Meeting Date:	September 6, 2023	Meeting Title:	Planning Commission
Submitting Department:	Planning Department	Presenter:	Katelyn Page
Agenda Item:	P23-105 Development Plan for a new 3-story mixed use building at the properties addressed 655 and 665 S. Cache Street	Public Comment:	Yes

Permit # P23-105 Parcel # : 22-41-16-33-1-69-005
Site Address: 665 S CACHE STREET
Project Name: Development Plan - 665 S. Cache St.

CONDITIONS	DEVELOPMENT REVIEW APPROVED WITH CONDITIONS P23-105 Development Plan ADDRESS: 665 S Cache Street OWNER: Newjack, LLC APPLICANT: Hoyt Architects 8/21/2023 Scott Mohror, (307) 733-3079 DATE OF SUBMITTAL: 8/15/2023 DATE OF MATERIALS: 8/11/2023 REVISION NO.: 01 The Engineering Division has reviewed your application for a DEVELOPMENT PLAN submitted on and with application materials as dated above. *The following comments are being provided for use in preparation of future applications and are required for sufficiency. CONSTRUCTION MANAGEMENT PLAN 1. Response to Department Reviews dated August 11, 2023, Engineering Reviews addresses the original engineering review comments with acknowledgement comments. 2. Engineering understands the CM Plan at this stage is not ful

DRAWING NO 1	DRAWING TITLE NEWJACK LLC VIEW CORRIDOR EASEMENT DON DUFFY	NELSON ENGINEERING P.O. BOX 1599, JACKSON WYOMING (307) 733-2087	DATE 12/18/20	
JOB NO 20-457-01			ENGINEERED	
			DRAWN	SK
			CHECKED	LR
			APPROVED	LR

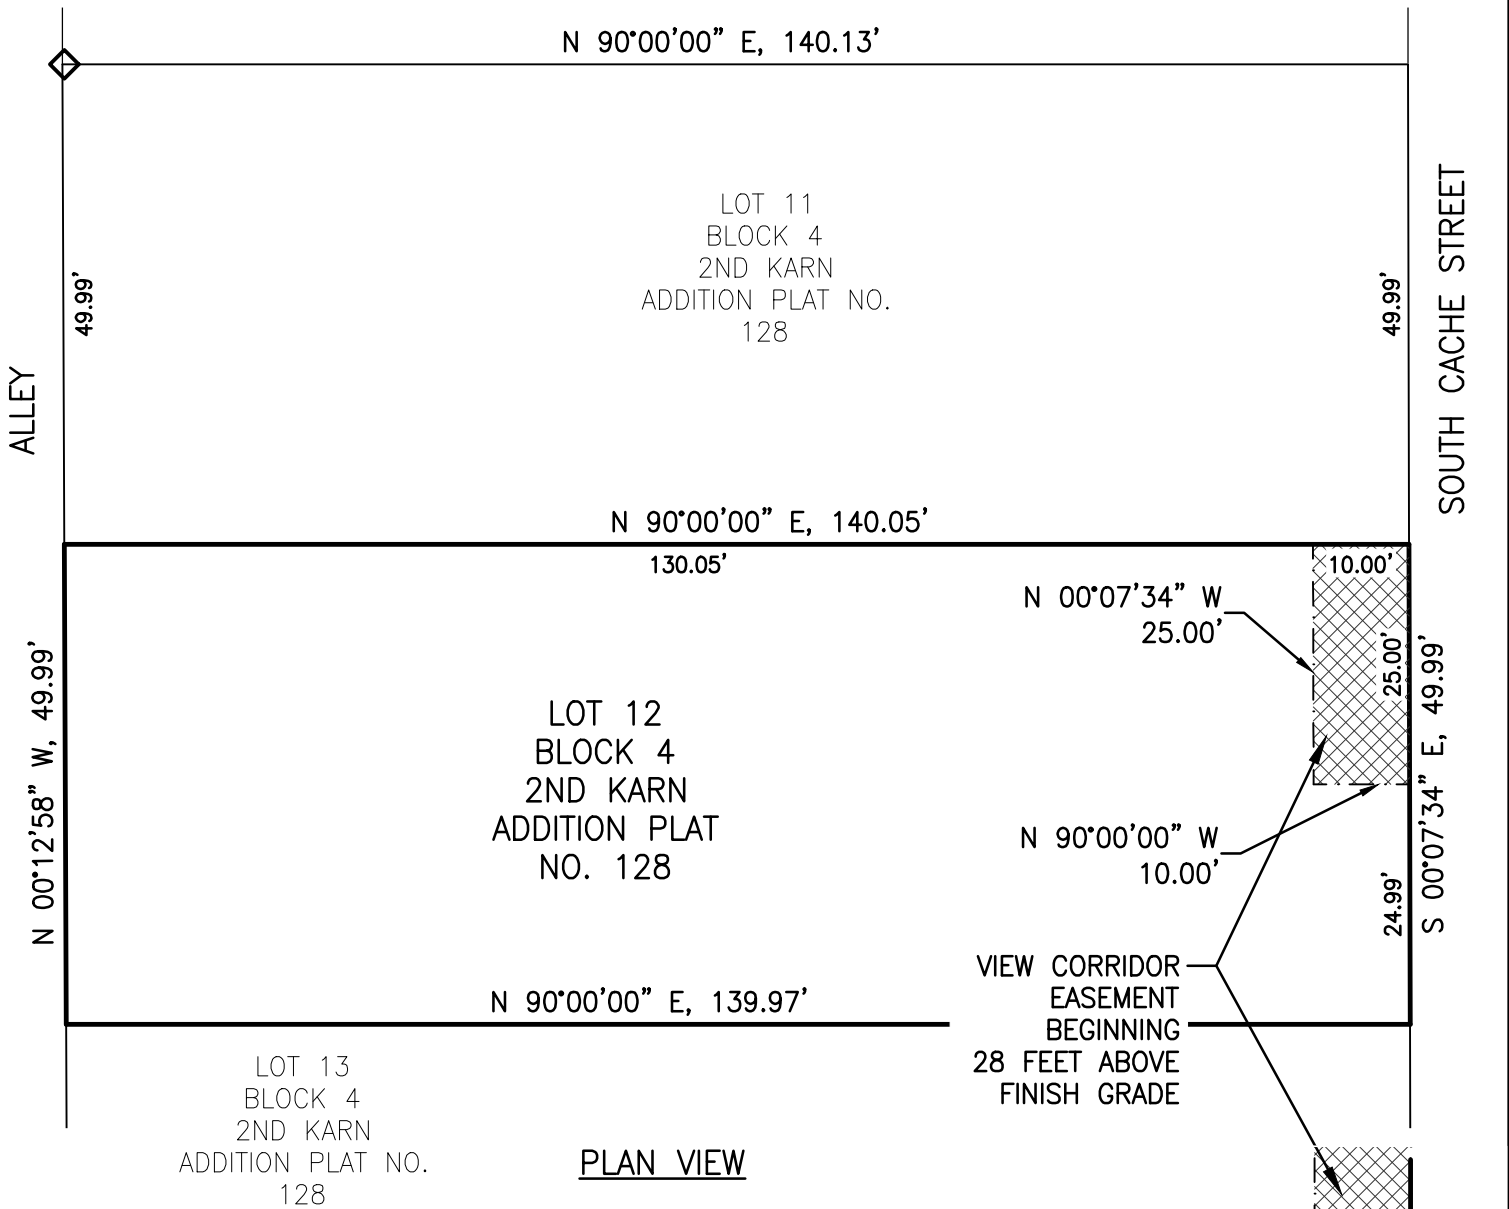
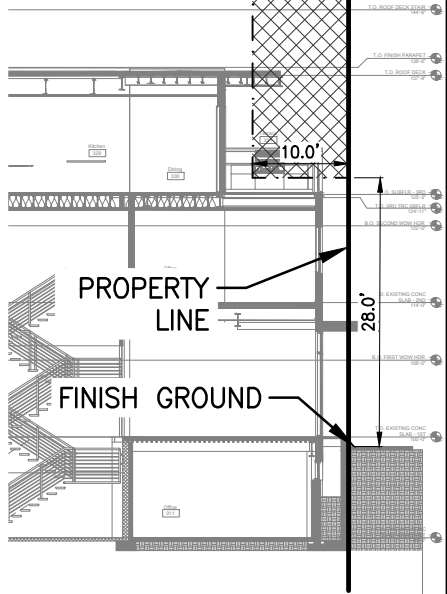
Page 6 is missing...maybe that
is where the exhibit goes,
however they are both Ex A?

SHEET TITLE: NORTHEAST GRADING PLAN	
DRAFTED BY:	KB
REVIEWED BY:	TK
PLAN VERSION	DATE
DEVELOPMENT PLAN	08/11/2023
PROJECT NUMBER	22155
SHEET	C3.2

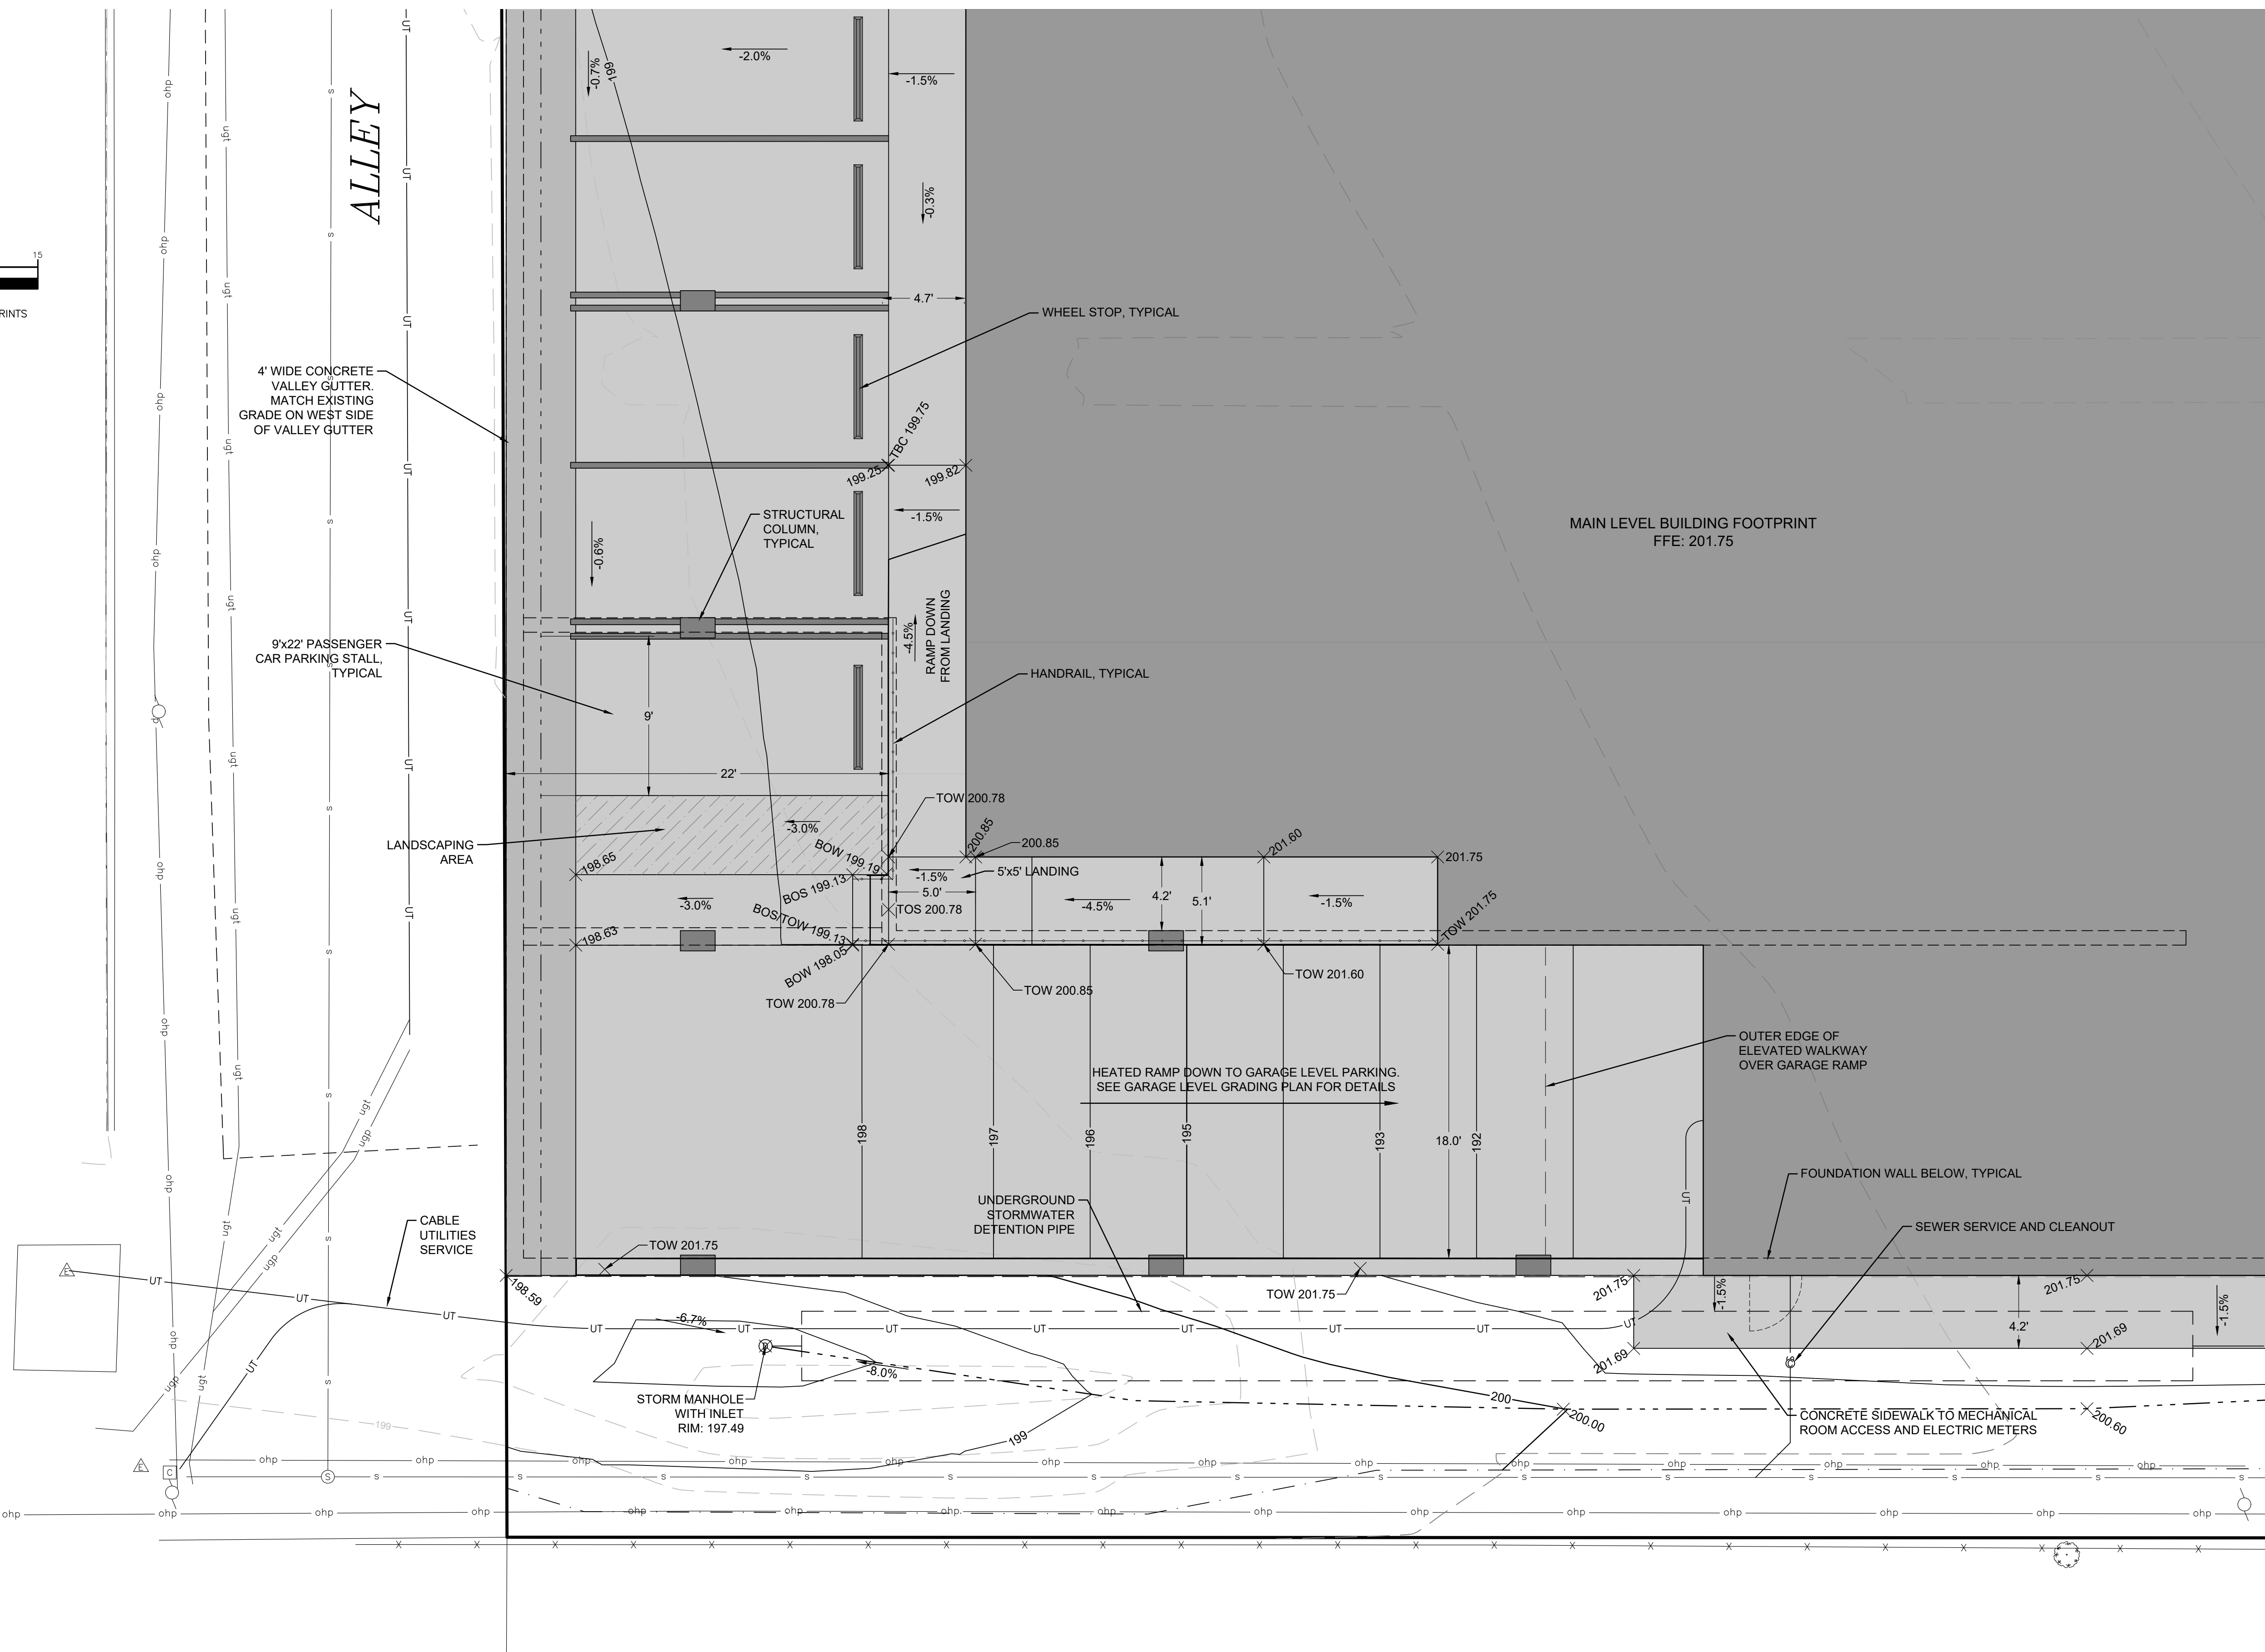
Verify structure setback to northern property line. Applicants LDR compliance table references 5 but A102 references 3-6 and civil C3.2 references 3.5 to structure. This setback is measured to structure and not to site development. See comment below on minimum sidewalk width.

Verify structure setback to eastern property line. Applicants LDR compliance table references 0 but A102 references 3-4 and civil C3.2 references 2.4 to a point that is not the actual structure. Staff notes location of property line is unclear on civil plan.

Verify structure setback to northern property line. Applicant's LDR compliance table references 5' but A102 references 3'-6" and civil C3.2 references 3.5' to structure. This setback is measured to structure and not to site development. See comment below on minimum sidewalk width.

Verify structure setback to eastern property line. Applicant's LDR compliance table references 0' but A102 references 3'-4" and civil C3.2 references 2.4' to a point that is not the actual structure.

L0.5

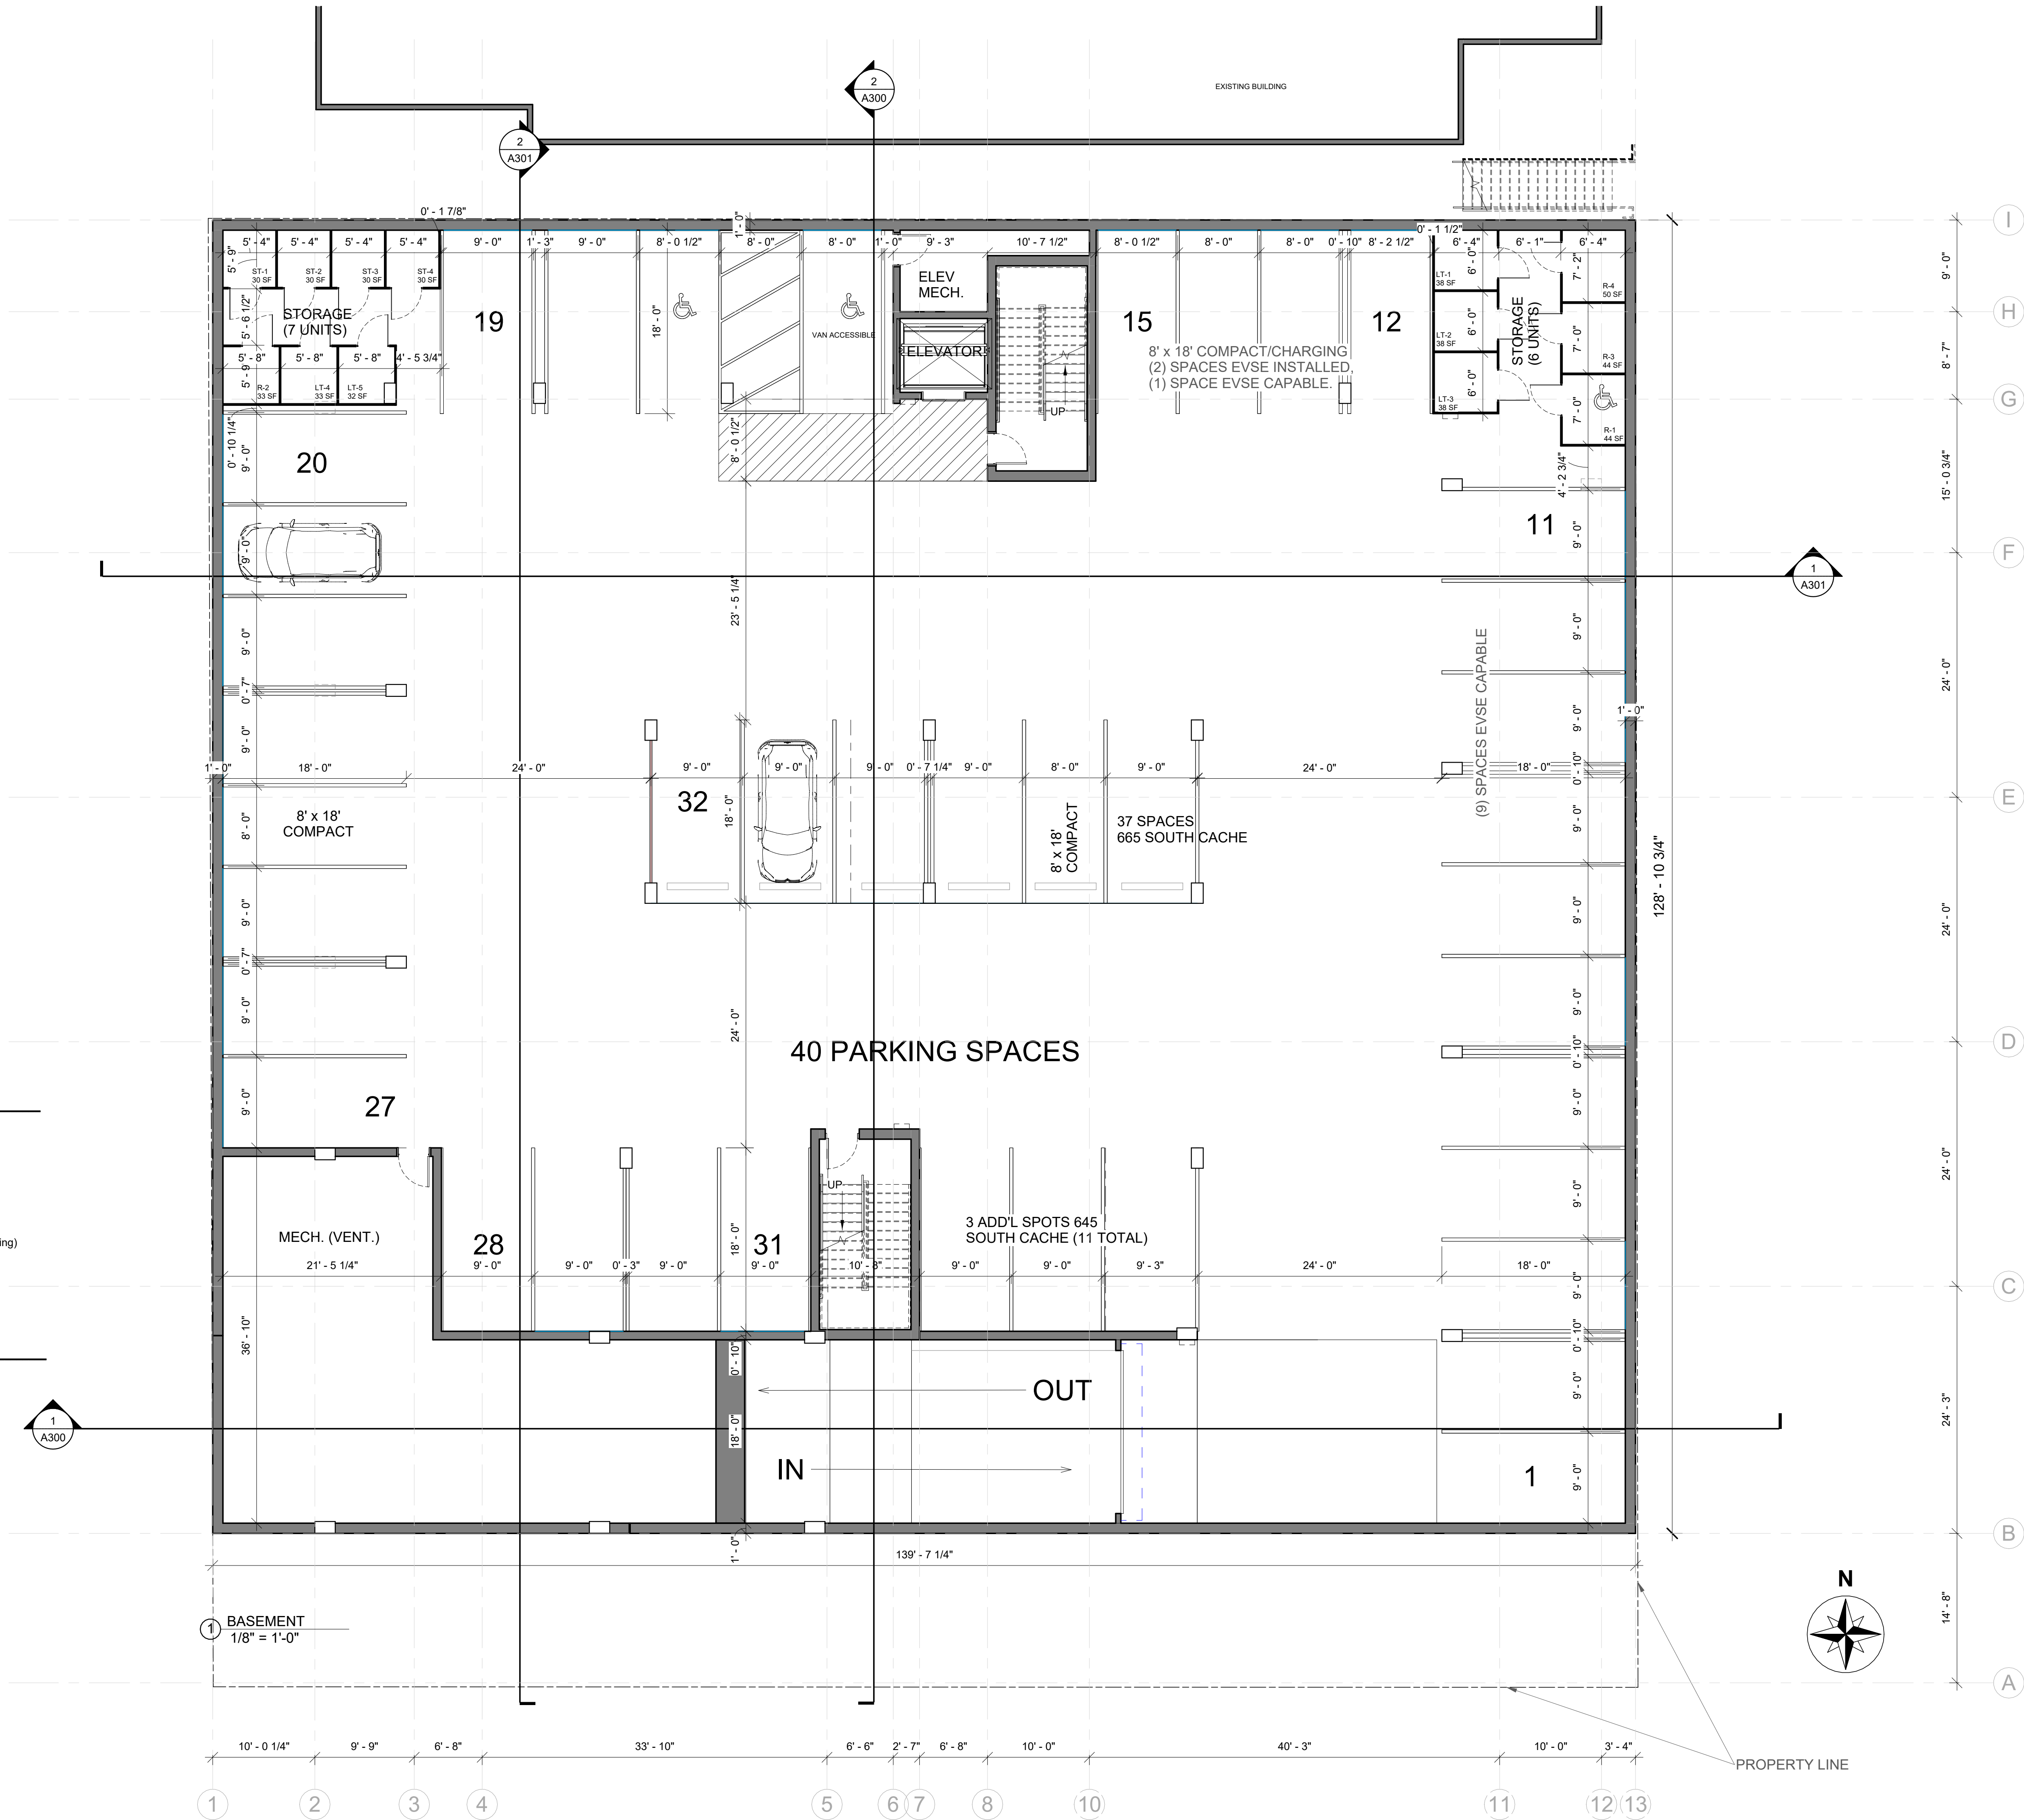
The sidewalk along the street frontage has been deducted from the property's gross site area in determining the landscape area calculations. Please see sheet L0.4 & L0.5.
